LEE'S SUMMIT
MISSOURI
Development Services Department

Development Services Staff Report

File Number	PL2022-216
File Name	Continued PRELIMINARY DEVELOPMENT PLAN – Macadoodles
Applicant	KC Blitz, LLC dba Macadoodles
Property Address	1499 SW Market St
Planning Commission Date Heard by	September 8, 2022 Planning Commission and City Council
Analyst	Hector Soto, Jr., AICP, Senior Planner
Checked by	Kent Monter, P.E., Development Engineer Manager

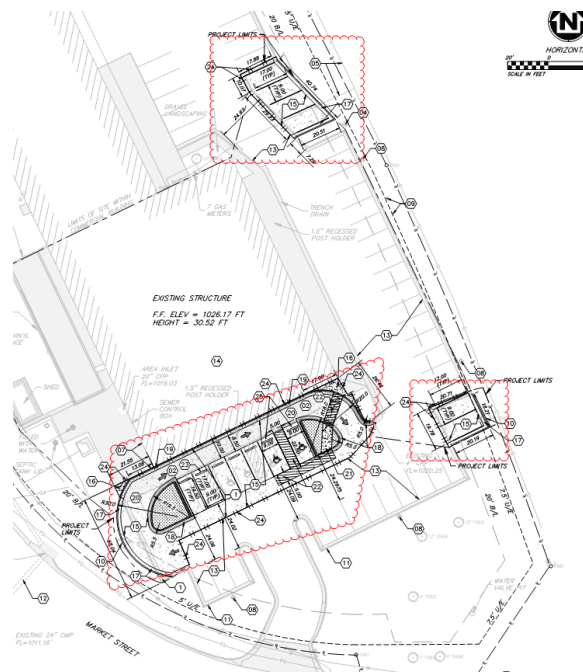
The scope of the site improvements associated with the subject application are clouded above for reference. The improvements include construction of a drive-through lane on the south side of the existing building and the relocation of six (6) parking spaces displaced by the proposed drive-through. The displaced parking spaces will be distributed between two areas along the retail center’s M-291 Hwy frontage. The proposed improvements result in the need for two modifications that are addressed under staff’s analysis.

- Required – Parking lots shall be set back a minimum 20' from the public right-of-way.
- Proposed – The relocation of two (2) parking spaces to the southeast corner of the existing parking lot results in a setback of 4'-4" from the M-291 Hwy right-of-way.
- Recommendation – At its closest point, the existing parking lot is set back 5'-9" from the M-291 Hwy right-of-way line and is set back approximately 67' from the nearest edge of pavement of the southbound M-291 Hwy travel lanes. The subject lot is irregular in shape and tapers down in width from north to south due to the curvilinear nature of the abutting M-291 Hwy and SW Market St rights-of-way. The relocated parking spaces maintain the existing parking lot boundary curb alignment for the site, but the abutting highway starts to turn back toward the site and thus results in a reduction to the setback. The proposed

reduction in existing setback by 1'-5" does not significantly alter existing site conditions and still yields a substantial separation of approximately 65' between the parking lot and nearest M-291 Hwy travel lanes. Staff supports the requested modification.

Drive Aisle Width. Staff does not support the requested modification.

- Required – Two-way drive aisles adjacent to 90-degree angled parking spaces shall have a minimum 24' of pavement width (excluding curb and gutter).
- Proposed – To accommodate the proposed drive-through lane along the south side of the building, the existing parking spaces immediately adjacent to the south side of the building are being shifted slightly to the south, resulting in 22' pavement width (excluding curb and gutter) for the adjacent drive aisle.

- Recommendation – The existing parking lot complies with the minimum 24' of pavement width for the two-way drive aisle throughout the retail center. The applicant's own actions stemming from the proposed construction of a drive-through facility result in the drive aisle pavement width reduction that causes the drive aisle width to fall out of the compliance with the UDO. While the proposed 22' of drive aisle pavement width is sufficient to accommodate two-way traffic circulation through the immediate area south of the building based on an accepted minimum standard that 10'-wide travel lanes provide adequate safety for vehicles, the reason additional pavement width is required for drive aisles with adjacent parking spaces is to provide adequate room to facilitate backing movements out of the parking spaces. Case in point, the UDO allows for only 20' of pavement width for two-way drive aisles where no parking spaces are present along the drive aisle. As proposed, 14 parking spaces on the south side of the building are directly impacted by the proposed reduction in pavement width. To meet the minimum required 24' of pavement width, the southern boundary of the existing parking lot will need to be pushed out 1.5' to 2' to the south.

Included as an attachment is a modification request by the applicant's design professional providing justification for the proposed pavement width reduction to 22'. The applicant wishes to include the curb and gutter to achieve the 24' drive aisle pavement width. However, the UDO explicitly excludes curb and gutter from the drive aisle pavement width measurement. The design professional's modification request states that requiring compliance with the minimum 24' pavement width creates a hardship because the project scope will grow in scale by needing to push out and reconstruct the parking lot's southern curb line. This perceived hardship on the applicant's side to comply with the UDO drive aisle pavement width standard is self-created. As previously stated, the existing parking lot currently complies with the minimum pavement width standards. Similar to how the six (6) existing parking spaces displaced by the drive-through are being relocated in order to remain compliant with the minimum parking requirement for the center, so should the existing south parking lot boundary be altered in order to remain compliant with the UDO's minimum drive aisle pavement width. Staff does not support the requested modification and recommends that the minimum 24' of pavement width (excluding curb and gutter) for a two-way drive aisle be provided for the south parking lot area as required by the UDO. In order to meet the minimum 24' drive aisle pavement width requirement, the southwest corner of the parking lot will require a modification to reduce the existing parking lot setback from 8' to approximately 7' along SW Market St. Portions of the existing parking lot further north on the retail center site currently maintain a 5' setback along SW Market St, so a 7' setback would not be out of character for the subject site.

1. A modification shall be granted to the minimum 20' parking lot setback from right-of-way, to allow a 4'-4" parking lot setback along the site's M-291 Hwy frontage.

2. A minimum 24' pavement width (excluding curb and gutter) shall be provided for the two-way drive aisle located south of the proposed drive-through facility. To meet this requirement, a modification shall be granted to the minimum 20' parking lot setback from the public right-of-way, to allow a 7' parking lot setback along SW Market St.
